Item No. 8.1.1
Design Review Committee
August 18, 2016

SUBJECT: **Case 20560: Amended Substantive Site-plan Approval Application – Nova Centre, Lands bounded by Argyle, Market, Sackville, and Prince Streets, Halifax**

Attachment G – Comparison of Existing and Proposed Market Street and Prince Street Elevations

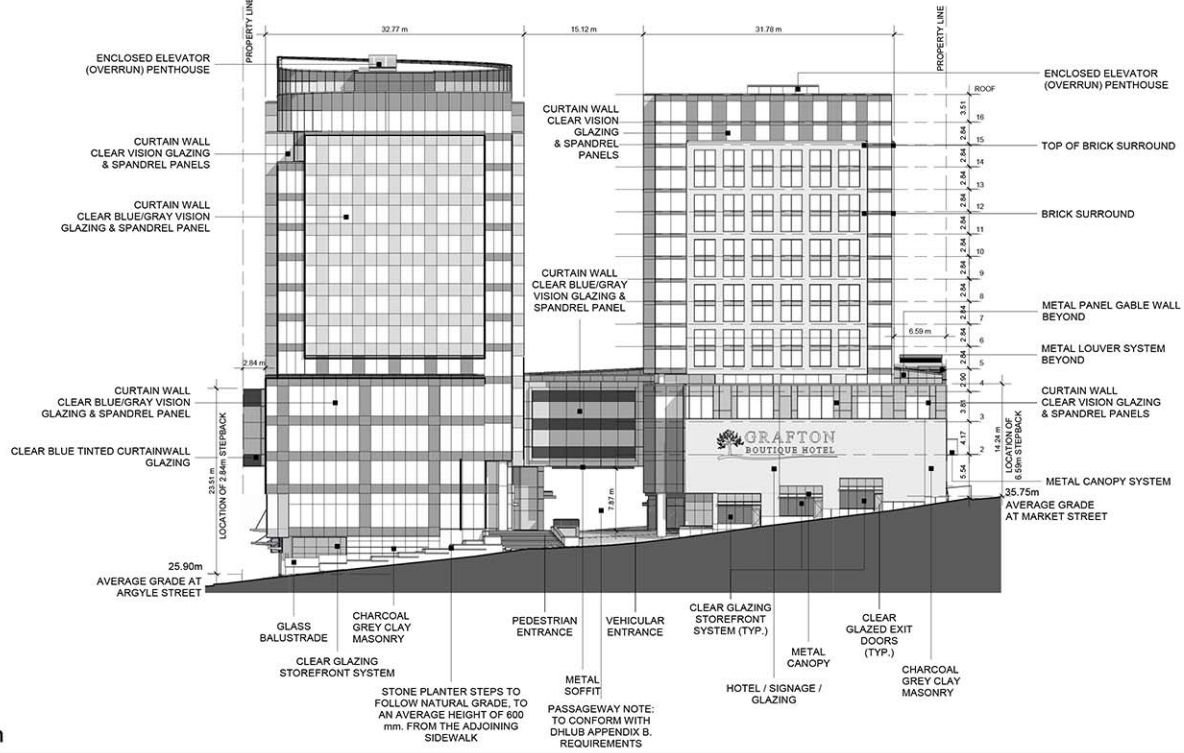
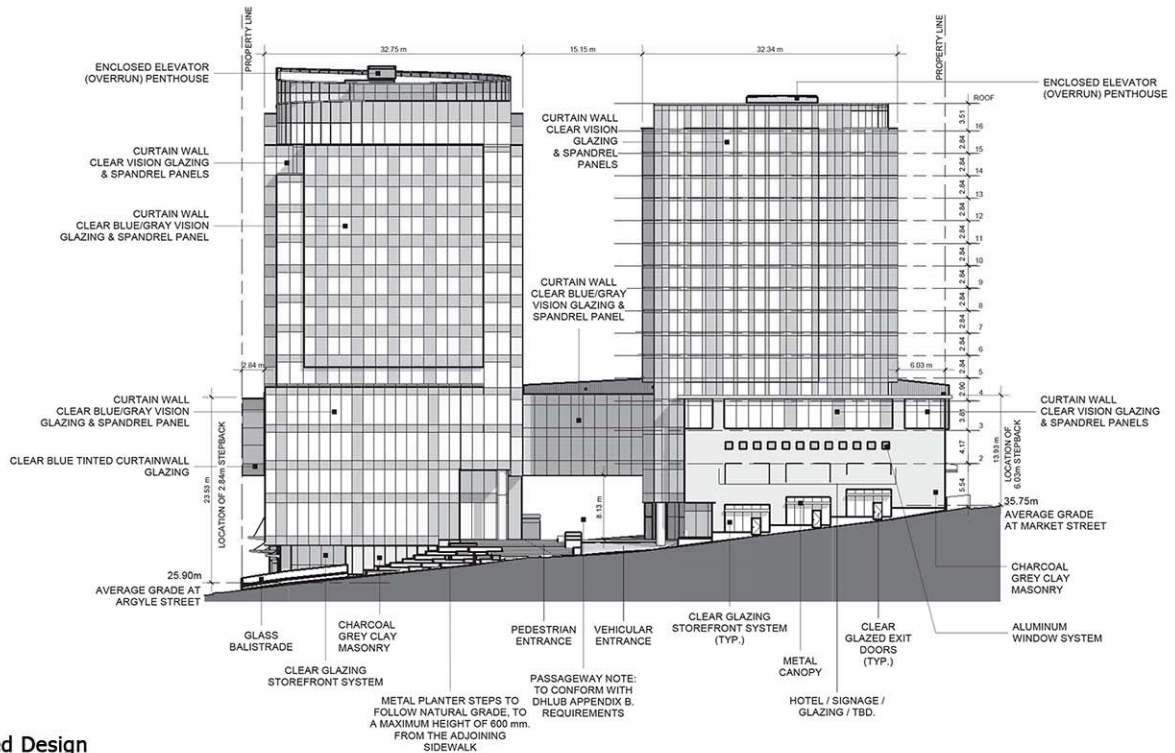
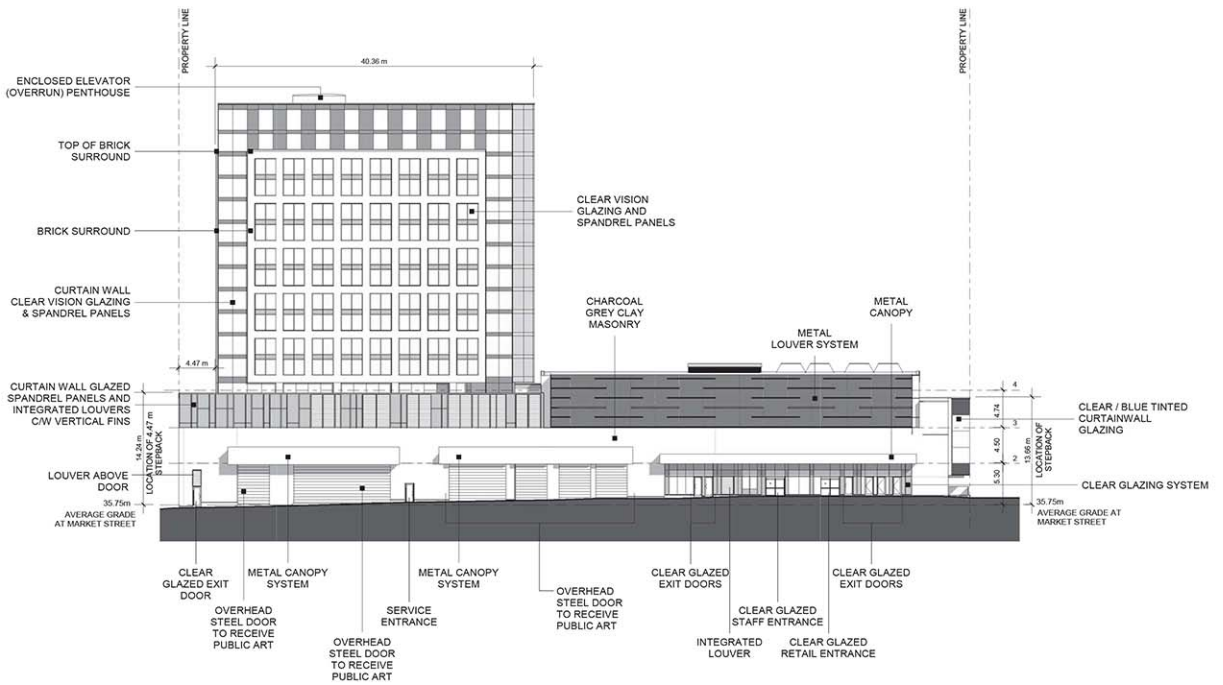
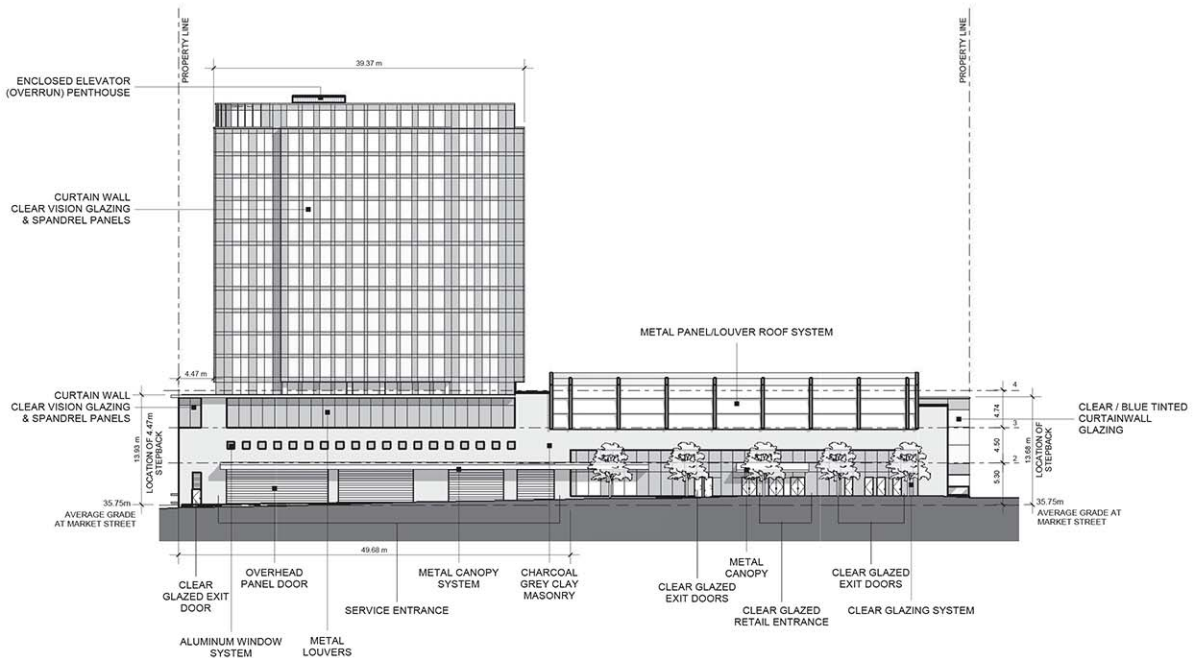
With regard to the need to accommodate the increased size of any mechanical equipment, a practical view should be taken with regard to the Design Manual conditions. However, with regard to matters such as proposed loading bay doors being on the outside of the building and composed of solid metal, it would be preferable for the mechanical equipment for the doors to continue to be on the inside of the building. In addition there should be a more in-depth consideration and attempt to use translucent materials for the doors. This would also allow for the reinstatement of the original canopies and square windows along Market Street as part of the current design. While the applicant has provided written information about the difficulties in accomplishing this, it does not seem to be absolute in discounting the original design. Therefore, it is suggested that the reinstatement of these original features be a condition of approval.

Along Prince Street, the original punched square windows are proposed to be removed to allow an increase in area for hotel signage. However, the existing wall face is sufficiently large and the area occupied by these windows does not adversely impact the availability of space for signage. Therefore, as a condition of approval, it is recommended that these original windows continue to be required.

- a) that the garage doors facing Market Street, open within the interior of the loading bay areas and be comprised of translucent materials and canopies be provided above the said doors; and
 - b) the square windows shown on the Market Street and Prince Street podiums on the June 3 2014 Site-plan Approval Plans continue to be required.
2. Approve the variance to the building height for rooftop mechanical equipment upon the sloped roof of the building in the vicinity of Market Street.
